ADDENDUM NO. 2

PROJECT TITLE: REPLACEMENT OF ROUTE 7 OVER NORWALK RIVER (BRIDGE NO. 02029)

PROJECT NO. 117-157
DRAWING NO. S-01
SHEET NO. 05.02.A2

DRAWING TITLE: GENERAL PLAN

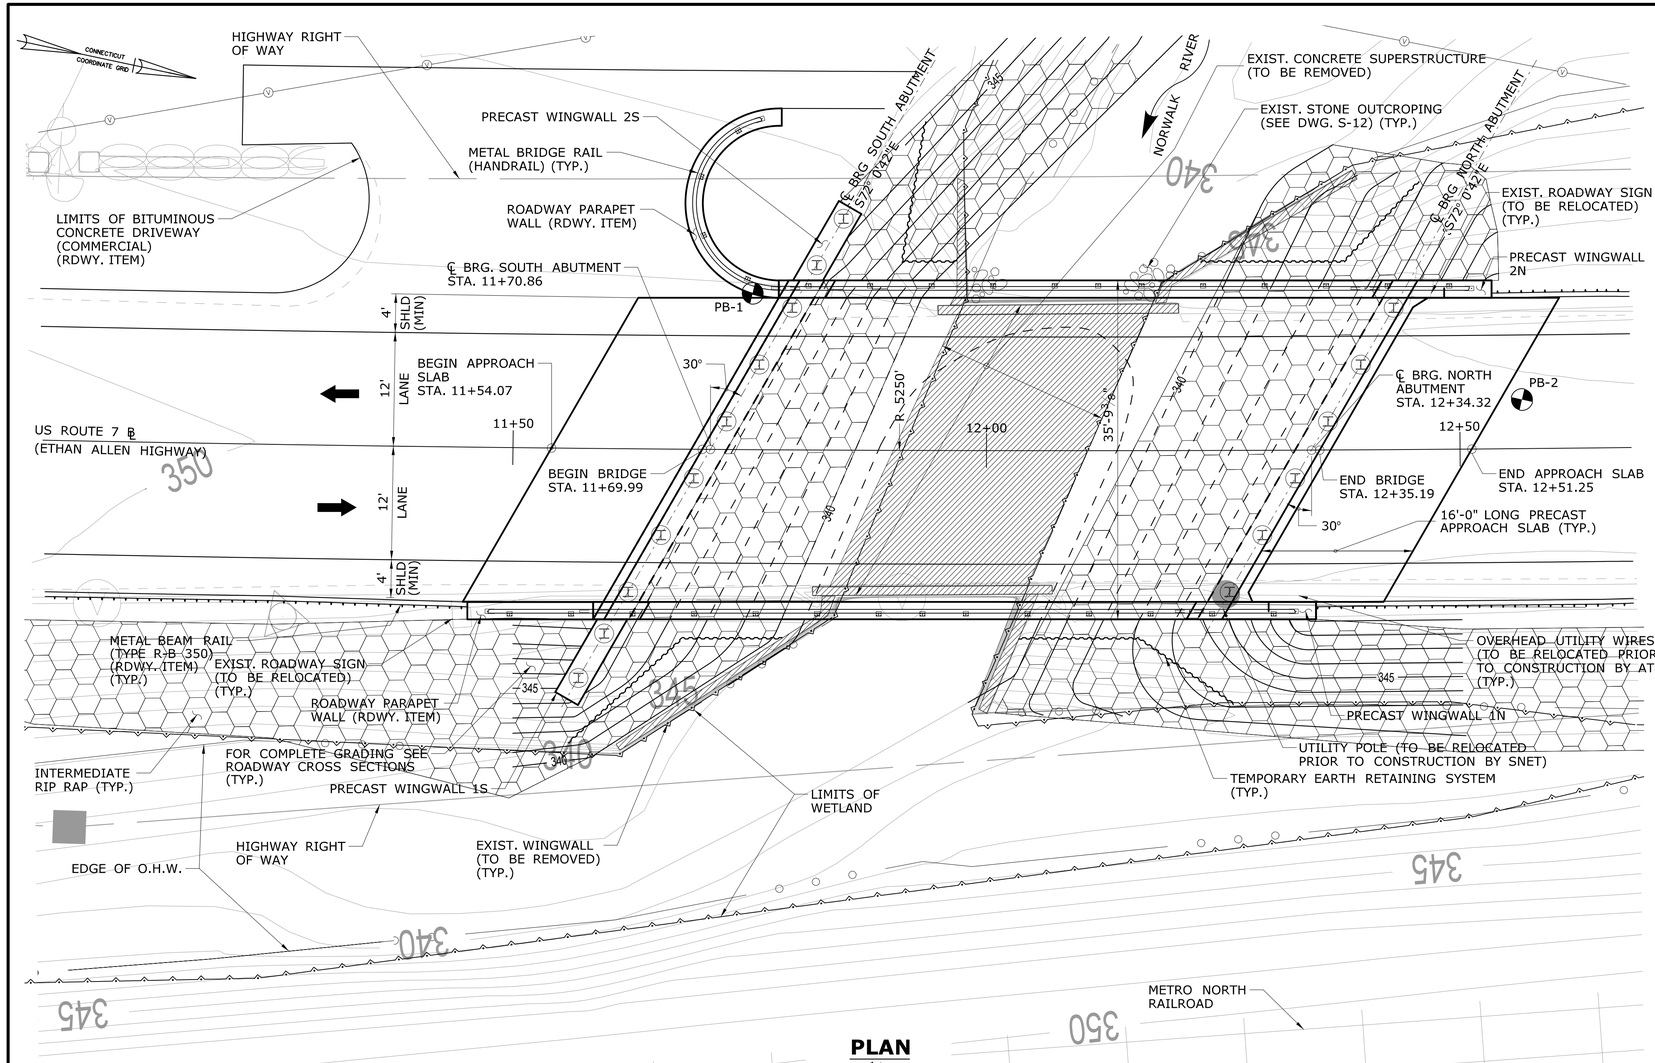
REV.	DATE	REVISION DESCRIPTION	SHEET NO.
1	3/24/15	ADDENDUM NO. 2 - REVISION TO QUANTITY	05.02

ITEM	UNITS	QUANTITY
STRUCTURE EXCAVATION - EARTH (COMPLETE)	CY	1345
PERVIOUS STRUCTURE BACKFILL	CY	150
HMA S0.5	TON	60
HMA S0.25	TON	26
REMOVAL OF SUPERSTRUCTURE	L.S.	1
PRECAST PRECOMPRESSED CONCRETE/STEEL COMPOSITE SUPERSTRUCTURE	SF	2275
PRECAST APPROACH SLAB	SY	115
CLASS "F" CONCRETE	CY	40
PRECAST SUBSTRUCTURE ELEMENTS	CY	67 1
DEFORMED STEEL BARS - EPOXY COATED	LB	2600
FURNISHING STEEL PILES	LB	54100
DRIVING STEEL PILES	LF	730
POINT REINFORCEMENT FOR STEEL PILES	EA.	16
TEST PILE (STEEL HP12x74 - 52' LONG)	EA.	1
DYNAMIC PILE DRIVING ANALYSIS (P.D.A) TEST	EA.	1
MEMBRANE WATERPROOFING (COLD LIQUID ELASTOMERIC)	SY	365
DAMPPROOFING	SY	110
TEMPORARY EARTH RETAINING SYSTEM	SF	880
TEMPORARY PRECAST CONCRETE BARRIER CURB (STRUCTURE)	LF	160
RELOCATE TEMPORARY PRECAST CONCRETE BARRIER CURB (STRUCTURE)	LF	80
METAL BRIDGE RAIL (HANDRAIL)	LF	200
REMOVAL OF EXISTING MASONRY	CY	120

DRAWING TITLE: STAGING DETAILS 2

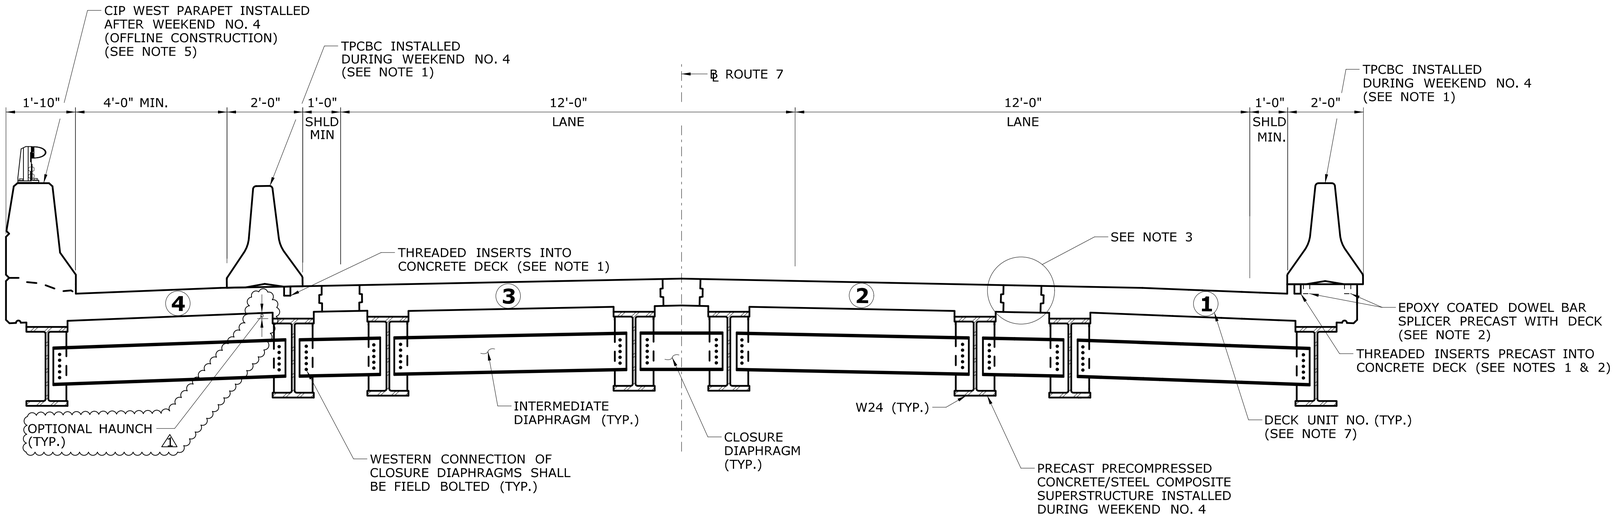
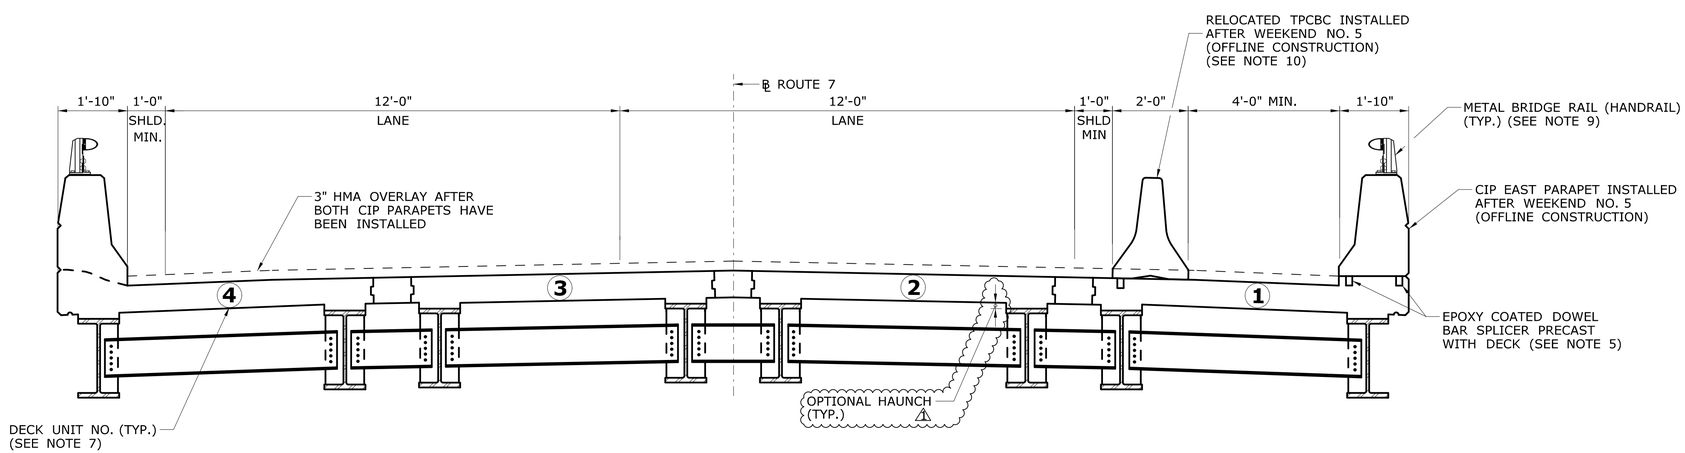
REV.	DATE	REVISION DESCRIPTION	SHEET NO.
1	3/24/15	ADDENDUM NO. 2 - ADDED HAUNCH NOTES	05.11

11. HAUNCH SHOWN IS OPTIONAL. THE CONTRACTOR MAY CHOOSE TO FABRICATE THE PRECAST SUPERSTRUCTURE UNITS WITHOUT HAUNCHES AT NO ADDITIONAL COST TO THE DEPARTMENT. THE CONTRACTOR IS RESPONSIBLE FOR MAKING ANY AND ALL NECESSARY ADJUSTMENTS, AND SHALL INDICATE THESE ON THE SHOP DRAWINGS. △1

DRAWING TITLE: NORTH ABUTMENT PLAN AND ELEVATION

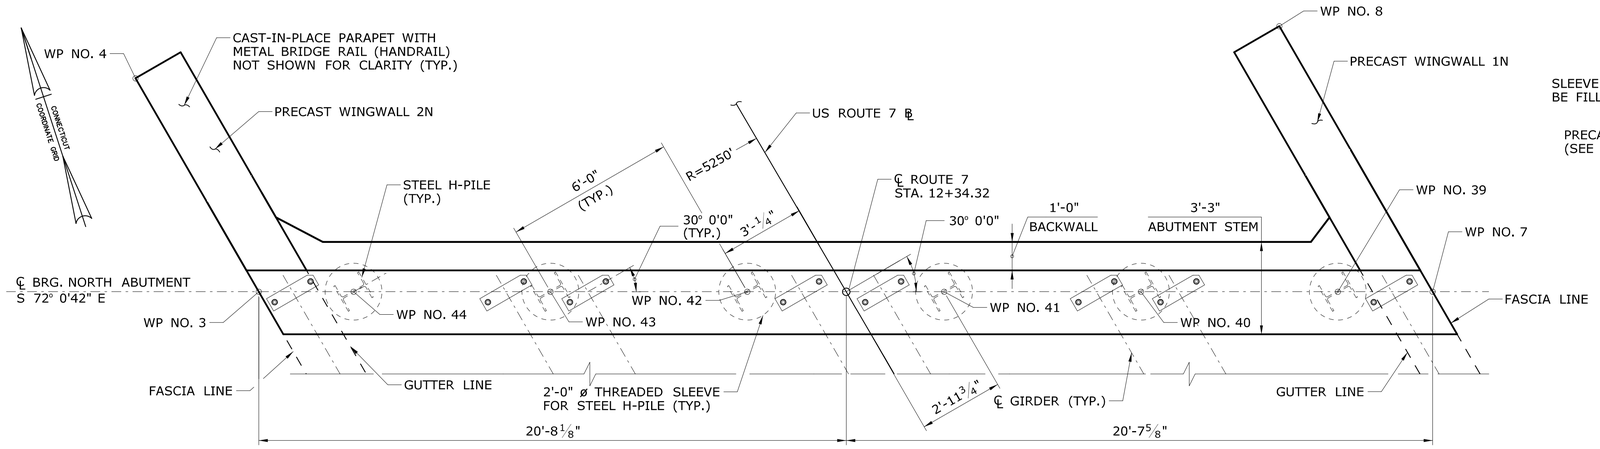
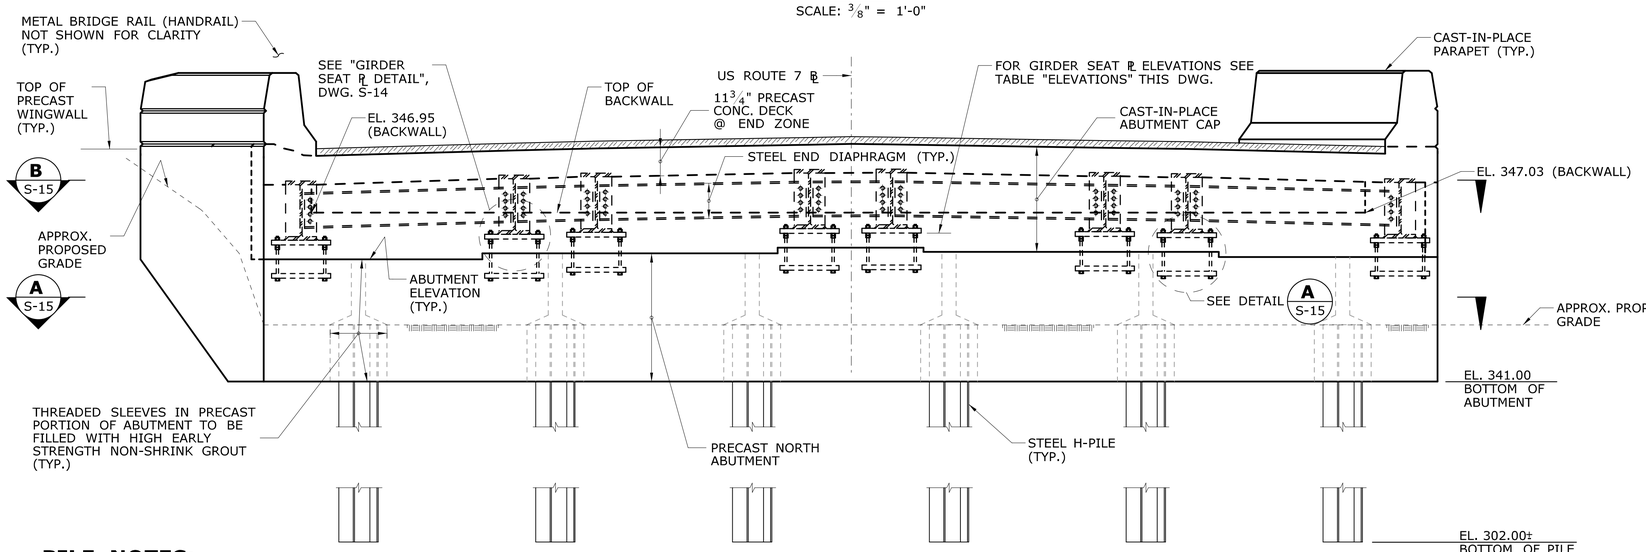
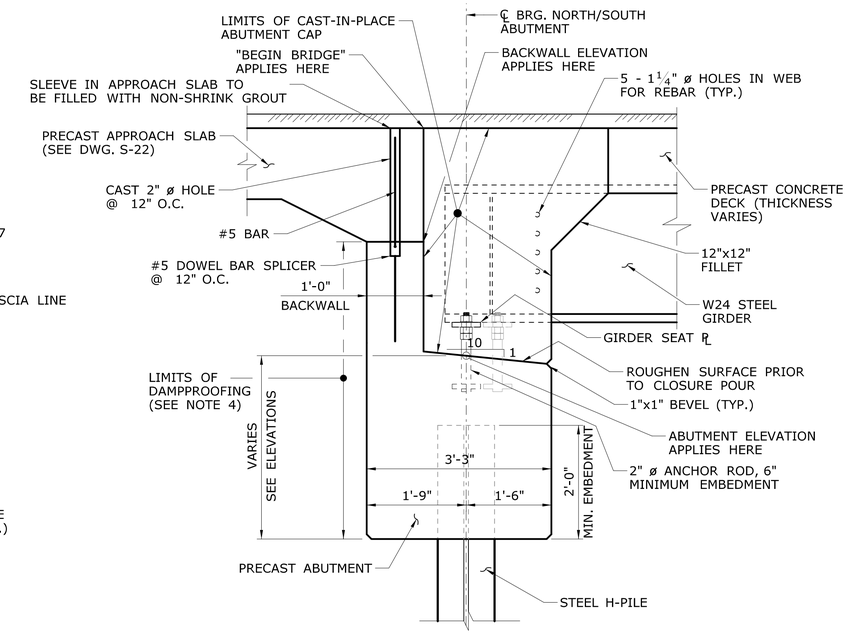
REV.	DATE	REVISION DESCRIPTION	SHEET NO.
△1	3/24/15	ADDENDUM NO. 2 - ADDED HAUNCH NOTE & GIRDER SEAT EL.	05.14

GIRDER	GIRDER SEAT ℄* WITH HAUNCH	GIRDER SEAT ℄* WITHOUT HAUNCH**	ABUTMENT
1	345.88	346.04	345.38
2	346.08	346.24	345.56
3	346.11	346.27	345.56
4	346.23	346.39	345.72
5	346.22	346.38	345.72
6	346.07	346.23	345.51
7	346.02	346.18	345.51
8	345.80	345.96	345.30

* SEE "DETAIL A", DWG. S-15
** SEE NOTE 10 △1

8. GIRDER SEAT PLATE AND ANCHOR PLATE SHALL CONFORM TO AASHTO M270, GRADE 50.
9. ANCHOR BOLT SHALL CONFORM TO AASHTO F 1554 GRADE 36.
10. DIMENSIONS AND ELEVATIONS SHOWN ARE BASED ON A 2" HAUNCH OVER GIRDERS. THE CONTRACTOR MAY CHOOSE TO FABRICATE THE PRECAST SUPERSTRUCTURE UNITS WITHOUT HAUNCHES AT NO ADDITIONAL COST TO THE DEPARTMENT. THE CONTRACTOR IS RESPONSIBLE FOR MAKING ANY AND ALL NECESSARY ADJUSTMENTS, AND SHALL INDICATE THESE ON THE SHOP DRAWINGS. △1

DRAWING TITLE: SOUTH ABUTMENT PLAN AND ELEVATION

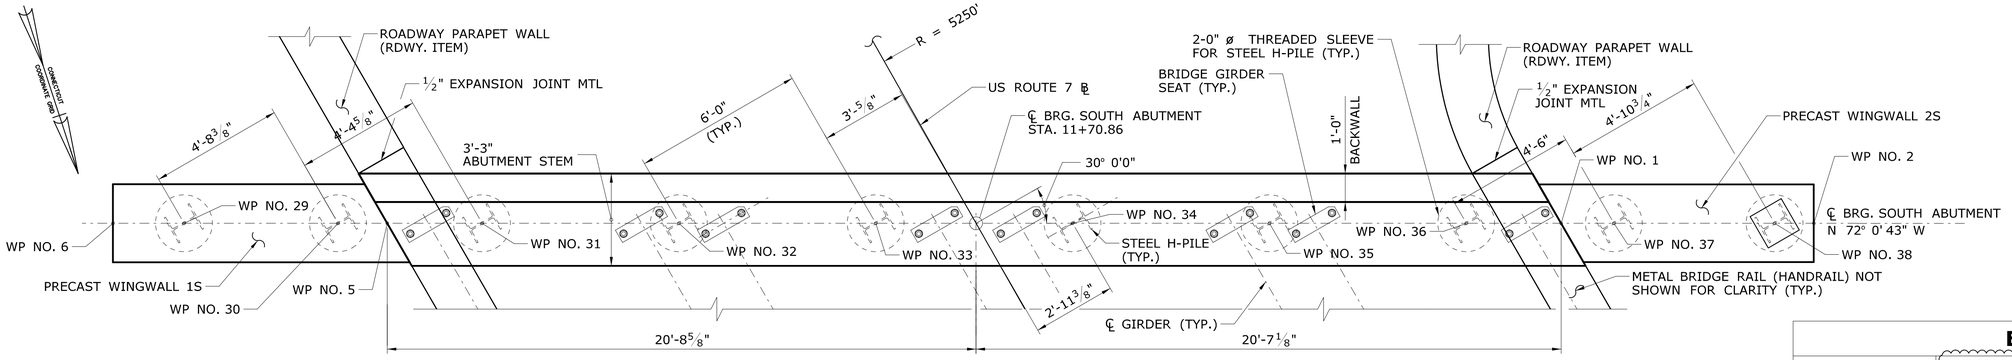
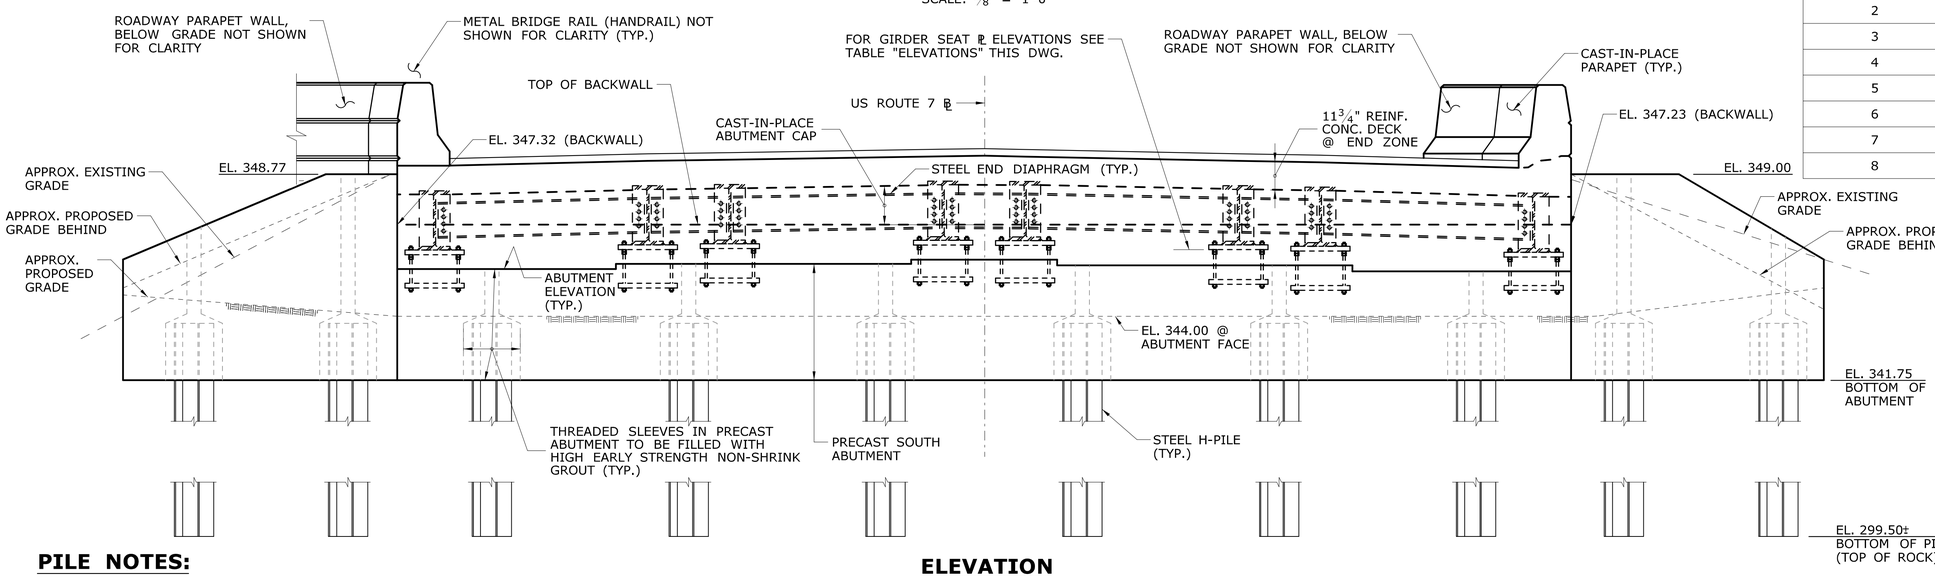
REV.	DATE	REVISION DESCRIPTION	SHEET NO.
△1	3/24/15	ADDENDUM NO. 2 - ADDED HAUNCH NOTE & GIRDER SEAT EL.	05.15

GIRDER	GIRDER SEAT ℞* WITH HAUNCH	GIRDER SEAT ℞* WITHOUT HAUNCH**	ABUTMENT
1	346.16	346.32	345.66
2	346.35	346.51	345.84
3	346.39	346.55	345.84
4	346.51	346.67	346.00
5	346.50	346.66	346.00
6	346.35	346.51	345.80
7	346.30	346.46	345.80
8	346.09	346.25	345.59

*SEE "DETAIL A", SEE DWG. S-15
**SEE NOTE 10 △1

8. GIRDER SEAT PLATE AND ANCHOR PLATE SHALL CONFORM TO AASHTO M270, GRADE 50.
9. ANCHOR BOLT SHALL CONFORM TO AASHTO F 1554 GRADE 36.
10. DIMENSIONS AND ELEVATIONS SHOWN ARE BASED ON A 2" HAUNCH OVER GIRDERS. THE CONTRACTOR MAY CHOOSE TO FABRICATE THE PRECAST SUPERSTRUCUTRE UNITS WITHOUT HAUNCHES AT NO ADDITIONAL COST TO THE DEPARTMENT. THE CONTRACTOR IS RESPONSIBLE FOR MAKING ANY AND ALL NECESSARY ADJUSTMENTS, AND SHALL INDICATE THESE ON THE SHOP DRAWINGS. △1

DRAWING TITLE: ABUTMENT DETAILS

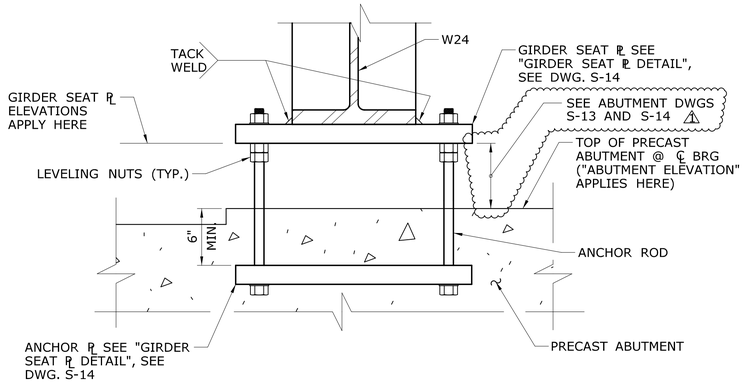
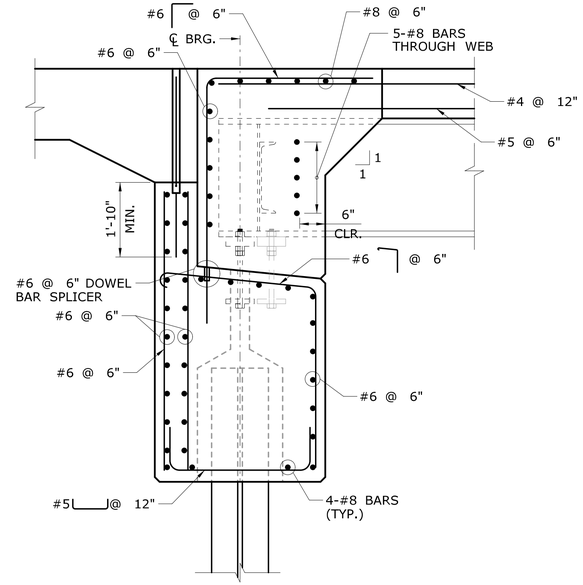
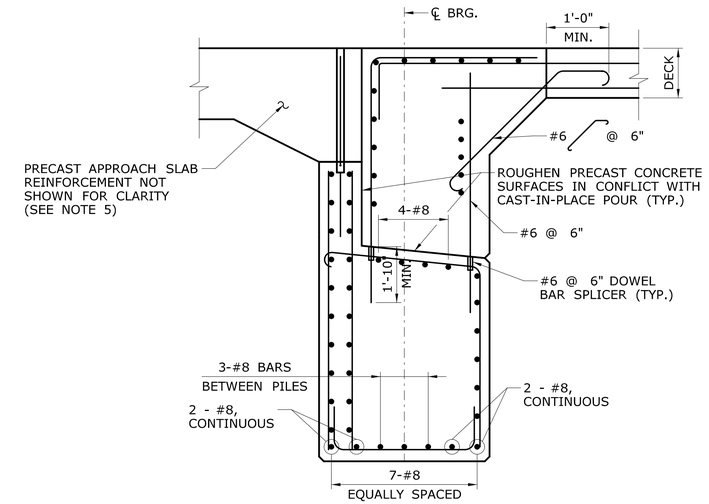
REV.	DATE	REVISION DESCRIPTION	SHEET NO.
1	3/24/15	ADDENDUM NO. 2 - REVISED ANCHOR ROD DIMENSION	05.16

DRAWING TITLE: FRAMING PLAN

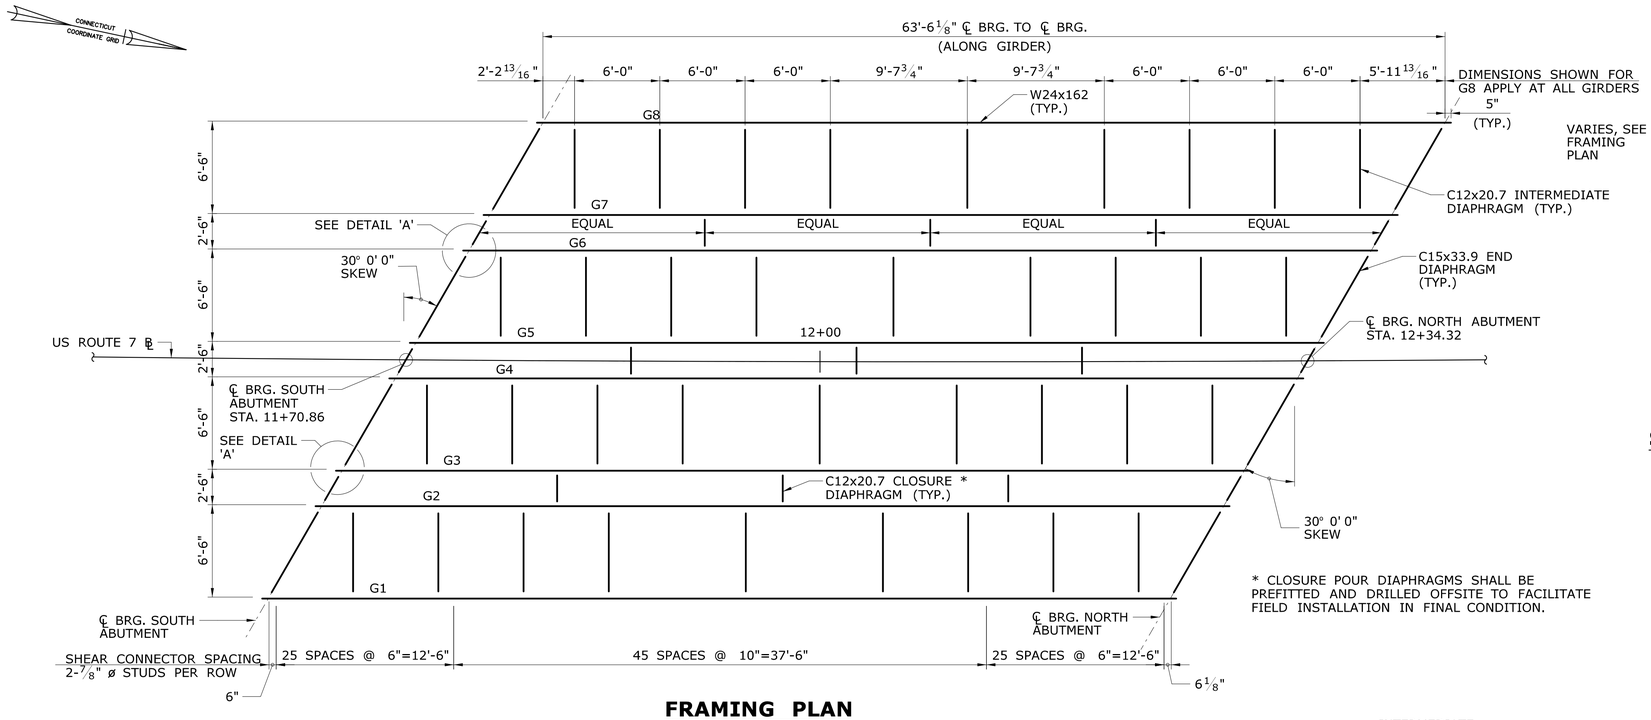
REV.	DATE	REVISION DESCRIPTION	SHEET NO.
1	3/24/15	ADDENDUM NO. 2 - ADDED HAUNCH CALLOUT & NOTE	05.20

*ADDITIONAL DEAD LOAD INCLUDES OPTIONAL HAUNCH WEIGHT. 1
